29/6-2-97A 11200 River View Drive
Potomac, (MP Site #29/6-2)

Marwood Entry Feature at River Road and River View Drive in Potomac

Resource: Master Plan Site #29/6-2
Marwood Gatehouse

POTOMAC
MAROOD
ENTRY GATE

B Roadway Plan
Scale: 1/16" = 1'-0"

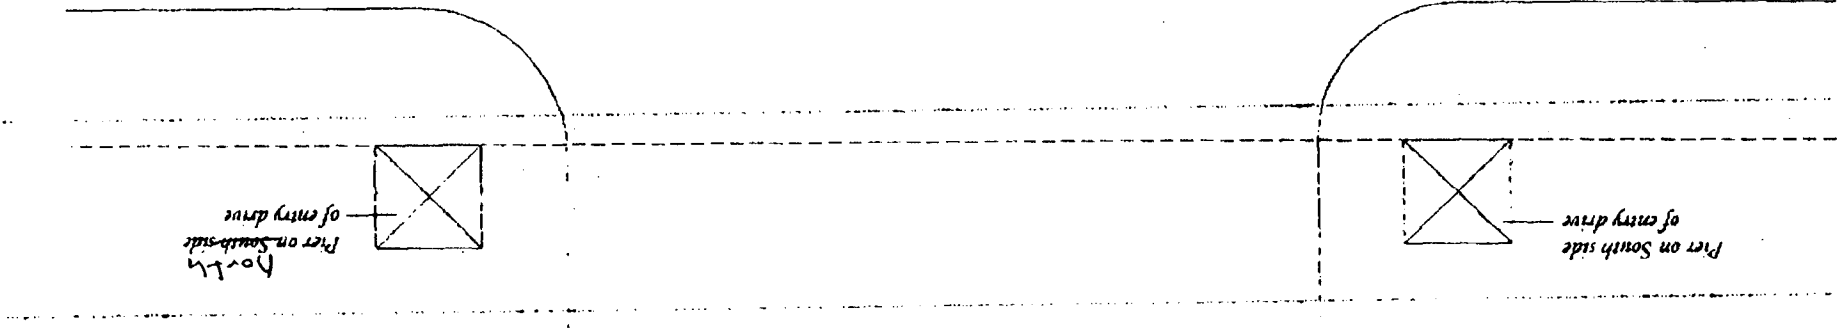
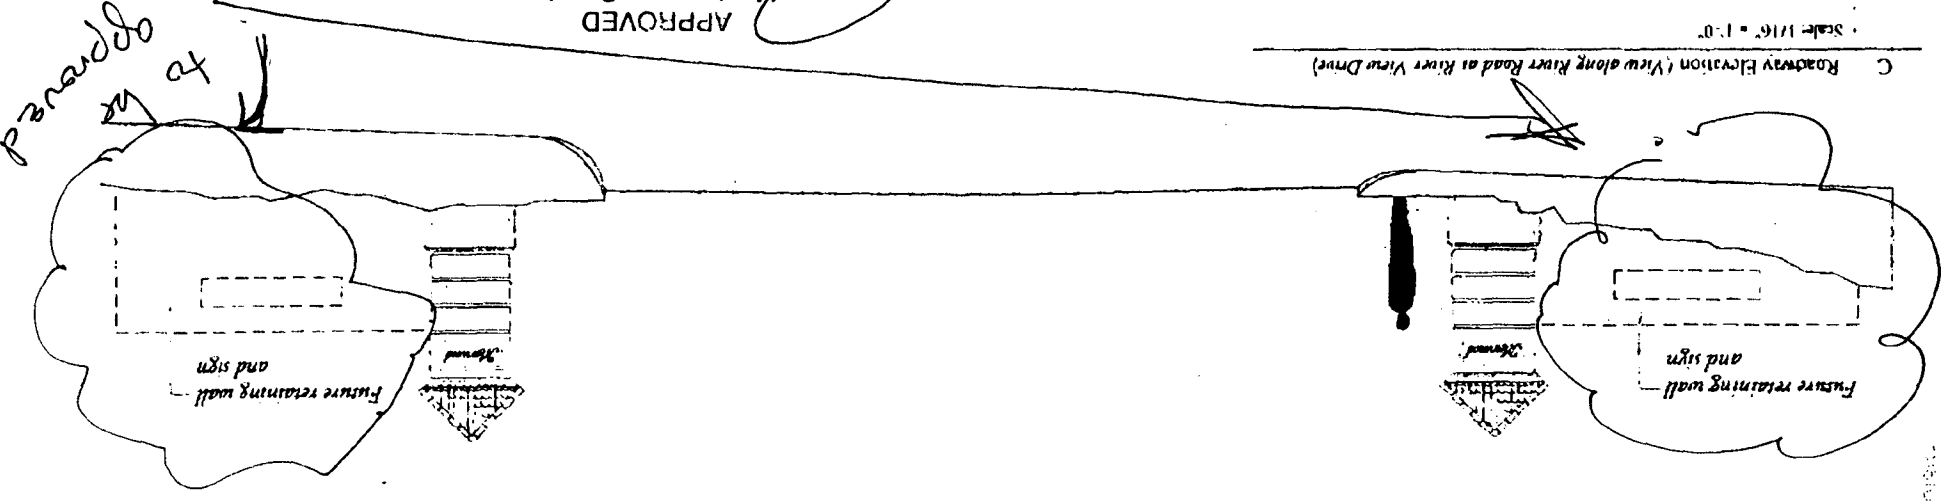
Enclosed please find our revised design for the entry feature at Marwood. Changes from the original submittal include:

- 1 The size is much smaller than what was previously proposed*
- 2 The wall and railing have been removed
- 3 A pier has been added to the north side of the entry drive
- 4 Both piers will be situated parallel to River Road
- 5 Material and colors will complement the nearby Marwood Gatehouse
- 6 Retaining walls and sign panels are marked for future addition

*We have taken considerable time to be sure the piers are adequately sized for their location at River View Drive while maintaining appropriate scale with the Gatehouse.

Mitchell - These are designed as a pair - if that has become a problem we need to possibly discuss either an alternative design or a suitable for obtaining the land needed for

completing the project - Perry.

ORIGINAL ENTRY WALL
FEATURE DESIGN

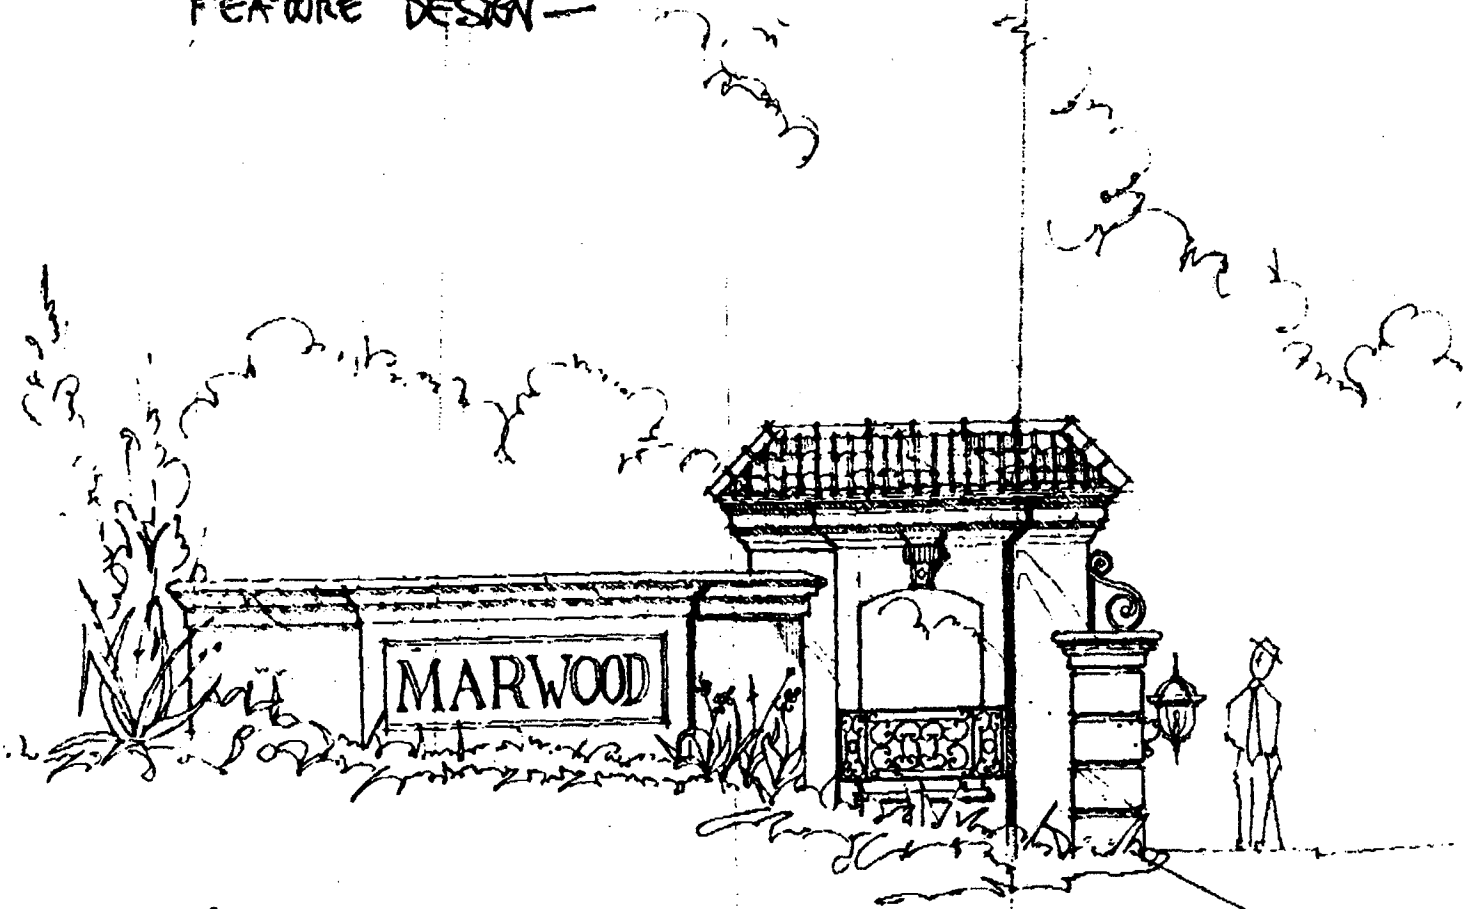
PERKY:

RAIL SHOWN AT ARCH WINDOW
IS LIKE TOP. MANSION

IRON RAIL
1" = 1'-0"

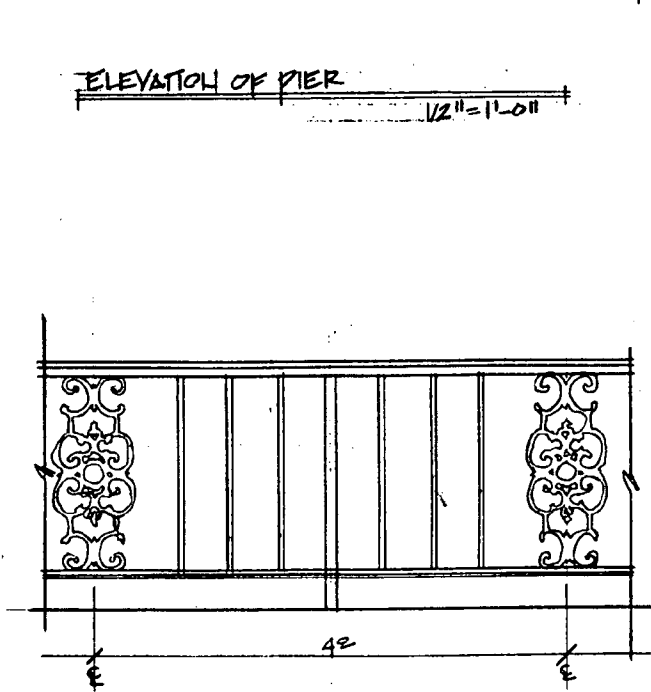
One further detail of the design that staff would also recommend modifying is the filigree work on the iron railings. This should be omitted from the railing design in the interests of simplicity and also, in staff's opinion, because the filigree mimics or parodies rather than evokes the design of the historic resource.

Enclosed please find one set of plans for the Marwood entry feature incorporating the changes suggested by the Historical Commission. Please let me know as soon as you can if the Commission will approve this feature.

FRONT ELEVATION
1/2" = 1'-0"

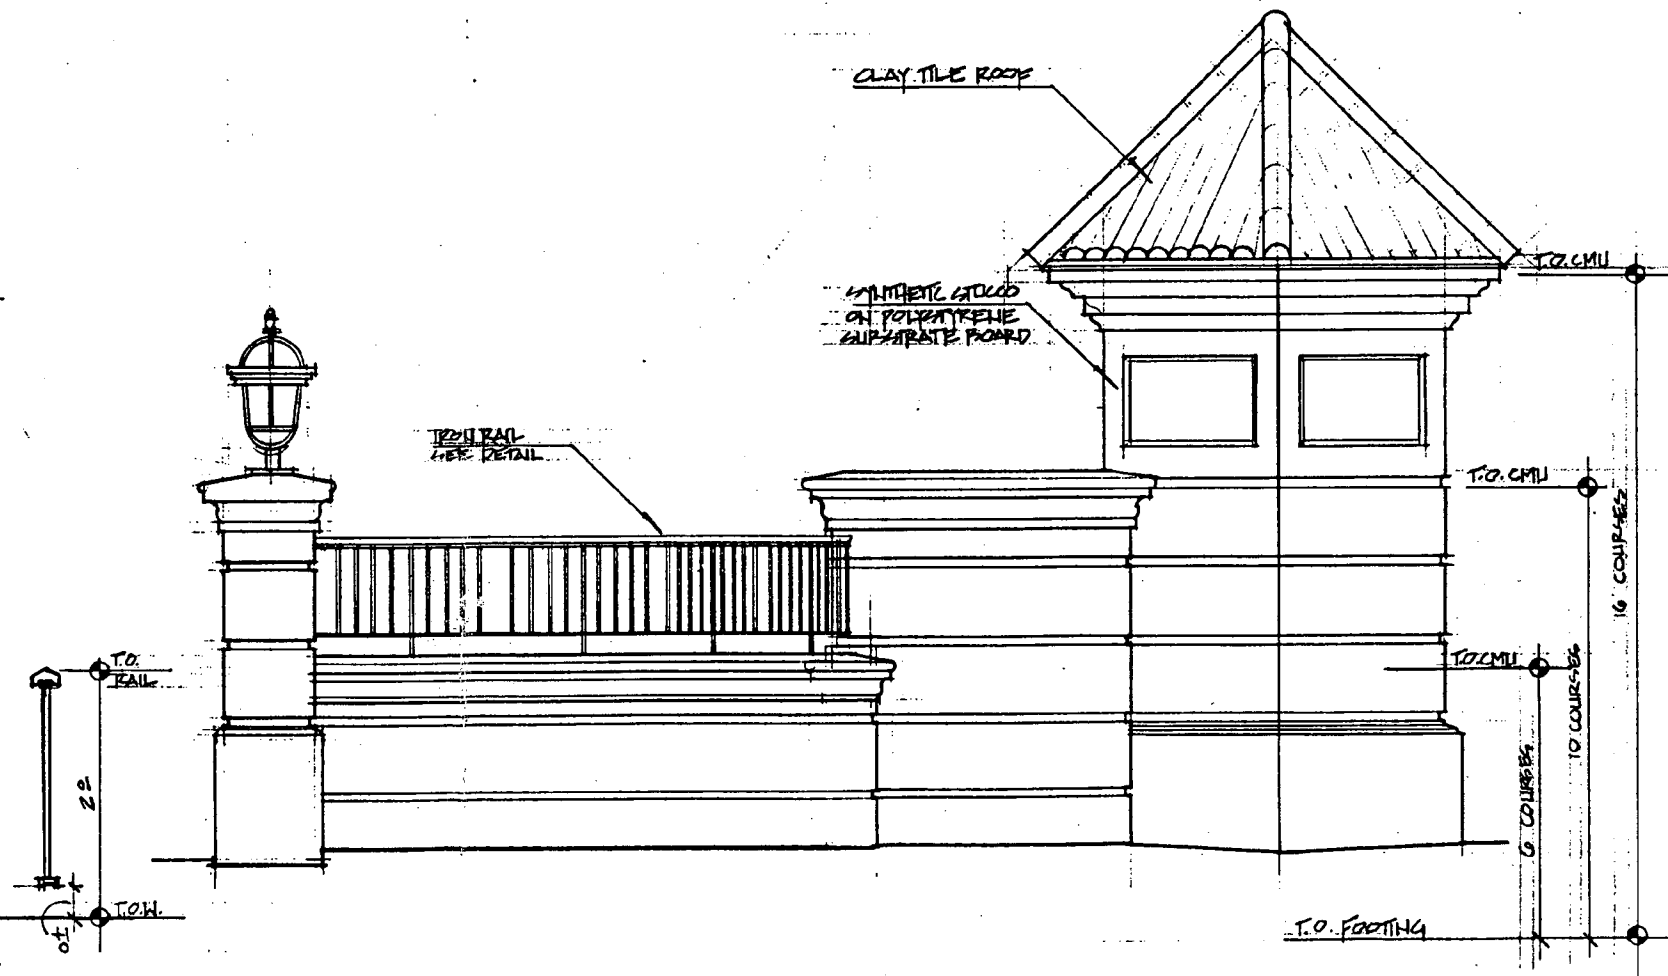
Are there 2 ?
